**EUCHAREENA ROAD RESOURCE
RECOVERY CENTRE**

EUCHAREENA ROAD
Cabonne Council

Road User Safety & Operational Assessment

November 2009

PLAN A

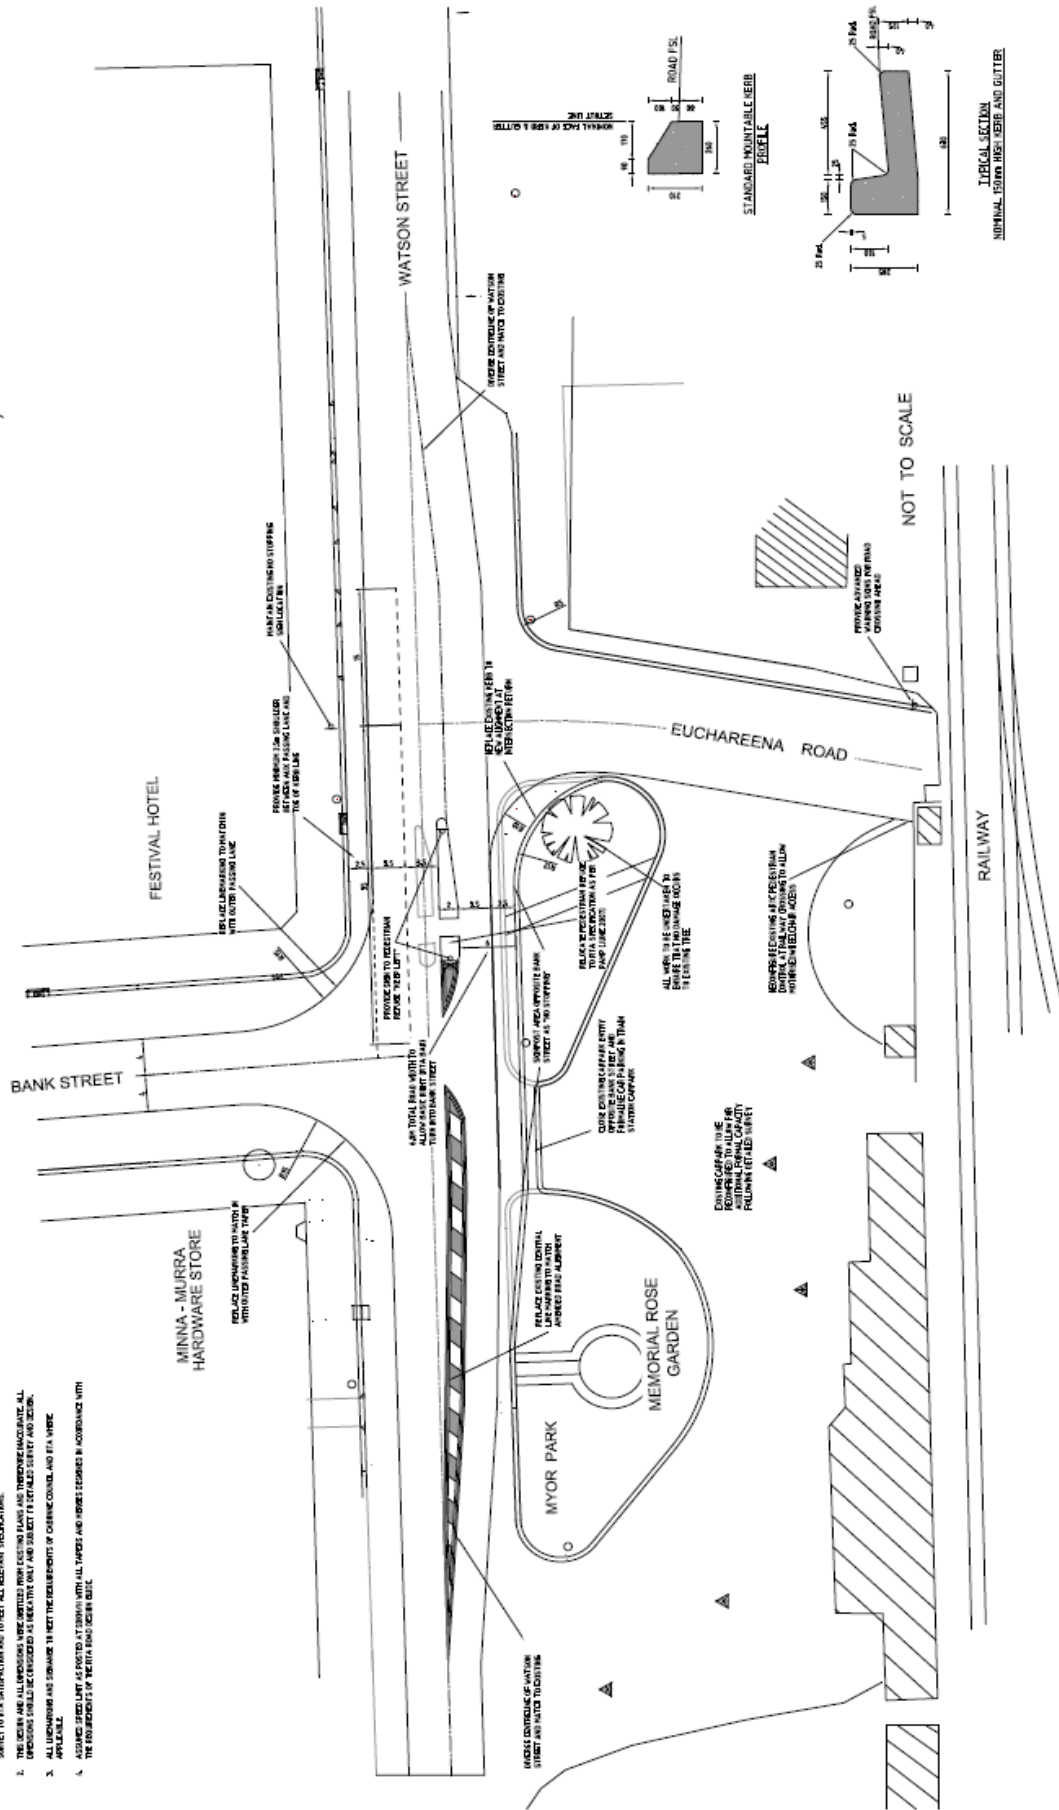
5	At the junction of Watson Street (Mitchell Highway) & Euchareenna Road and Bank Street	The pedestrian refuge within Watson Street is located within a high vehicle conflict area. Driver appreciation of pedestrian activity is competing with vehicles entering and leaving both Bank Street and Euchareenna Road. There is no provision in the western kerb for disabled access. It was observed wheelchair access is north of Euchareenna Road to cross Watson Street to driveways on the western kerb. Given the impact of turning vehicles and heavy vehicle (HV) content within the traffic stream and the potential for vehicles to queue through the refuge the location of this pedestrian refuge is considered inappropriate.	Intolerable	HIGH	Refer Appendix 1
6	At the Euchareenna Road RCC Access	Given the proposed hours of operation of the development roadway lighting should be accommodated within the final design.	Medium	HIGH	Refer Appendix 2
